Case number:	10768AB-07
Address:	2151 American Blvd W; and 8005 and 8051 Penn Avenue
Application type:	1)Rezone from General Business Zoning District B-3 and General Business Zoning District B-3 (PD) to Freeway Mixed Use Zoning District (Planned Development) (Case 10768A-07); 2)Preliminary Development Plan for a commercial mixed use center (Case 10768B-07
Applicant:	United Properties

Originator Community Development	Item Rezoning and Preliminary Development Plan	#	
Agenda Section HEARINGS/PUBLIC INPUT Development Business	By CDC	Approved	Date

Case 10768AB-07

PHASE I: SITE PLAN

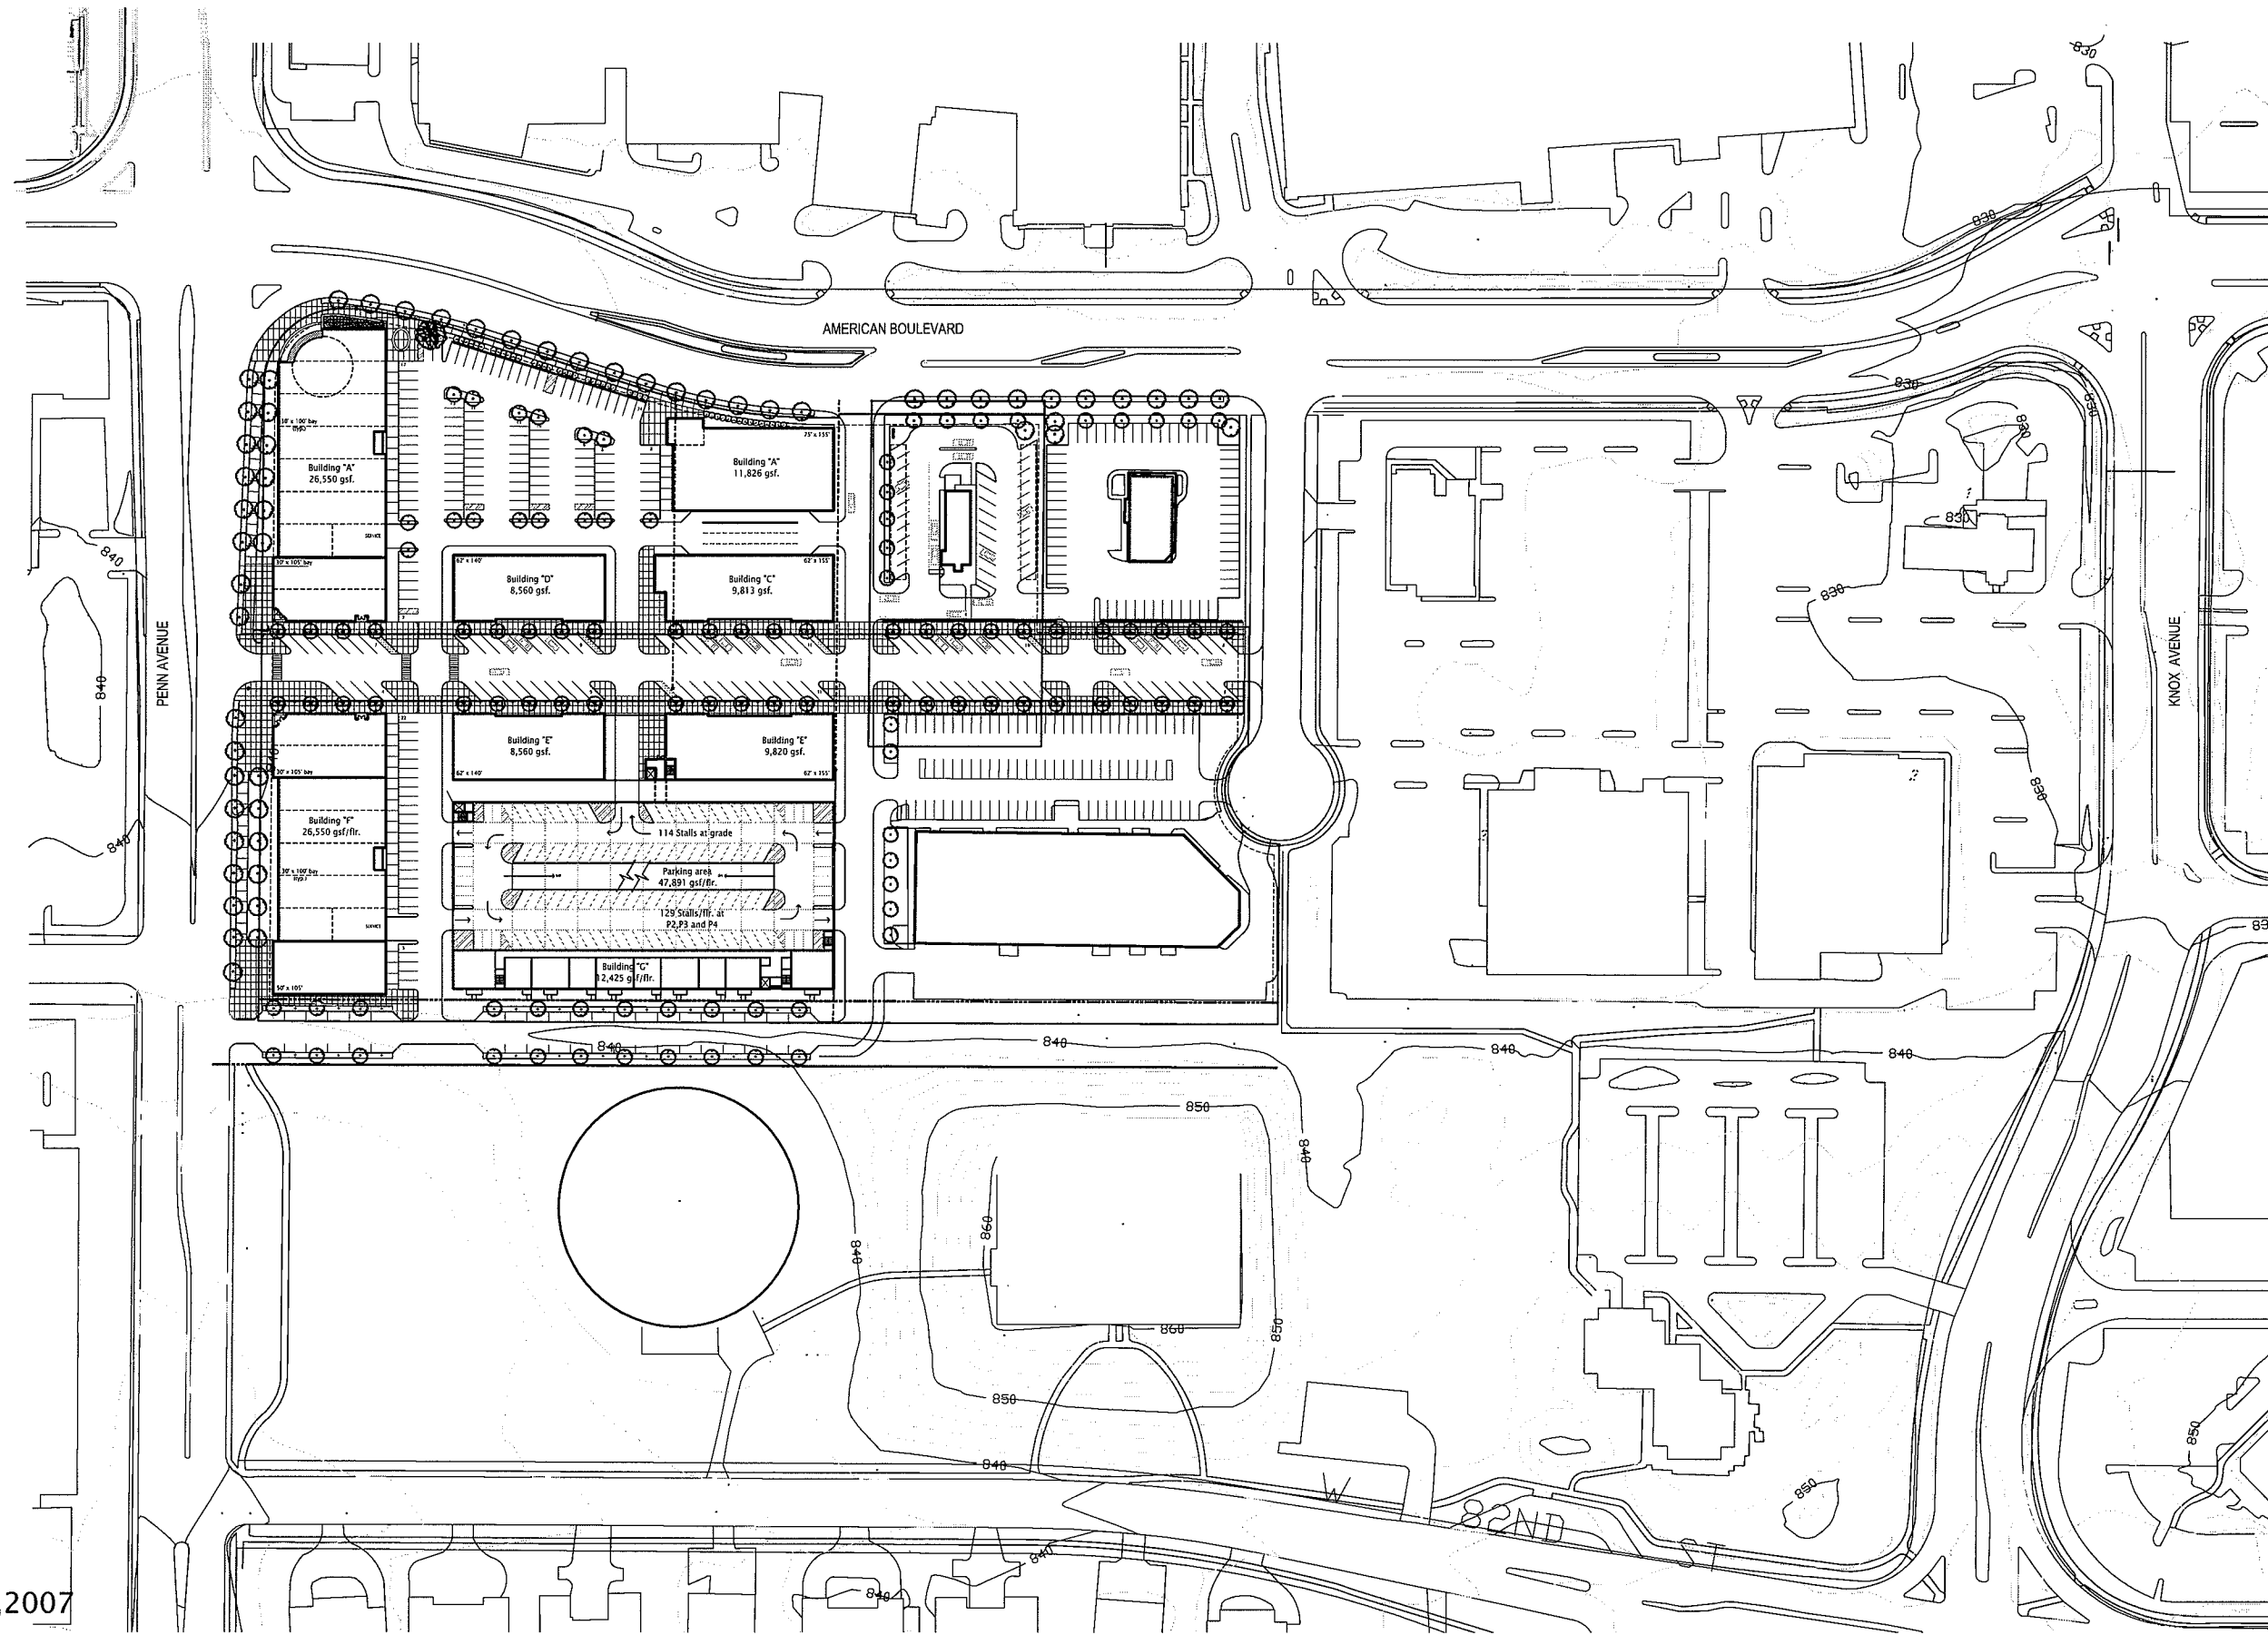
Section 21.205.05 Building Footprint - The Code requires that a minimum of 60% of the building footprint area on a site must be two stories or more in height. The site has a ratio of 49% of building footprints with 2 stories or more, not counting the parking ramp.

Section 21.205.05(c)(2)(F) Drive Through Facilities- The code requires a maximum of one drive-through per business. This development proposes two drive-throughs for building C and one at building B. There is also a third lane which allows cars to bypass either of these drive-throughs to exit onto "C" street. There is a Code amendment proposed which, if adopted will remove this provision and allow a second stacking lane for the building. If not approved, the applicant would like Planned Development Flexibility on this requirement.

Section 21.205.05 (c)(5)(B) Streetside Entrance- The code requires a streetside entrance for each building and to each individual tenant. The applicant is asking for flexibility on this standard along Penn Avenue and American Boulevard. The exact degree of flexibility will be determined at the Final Development Plan.

Section 21.301.01 Building Floor Area in the C-5 zoning district requires 20,000 square feet per building. Individual buildings for retail uses may not meet this standard, although the site as a whole has 100,000 square feet in retail and 100,000 square feet in offices uses.

The development does not meet the front yard setbacks along public streets at either Penn Avenue or American Boulevard, nor along internal streets. Internal property lines developed as part of the final development plan may not meet rear or side setbacks.

In Case 10768AB-07, Staff recommends approval of a Rezoning from General Business (B-3) and General Business Planned Development B-3 (PD) to C-5 Freeway Mixed Use Zoning District Planned Development (PD) and a Preliminary Development Plan for a commercial mixed-use center at 2151 W. American Blvd., and 8005 and 8051 Penn Avenue S. subject to the following conditions being satisfied:
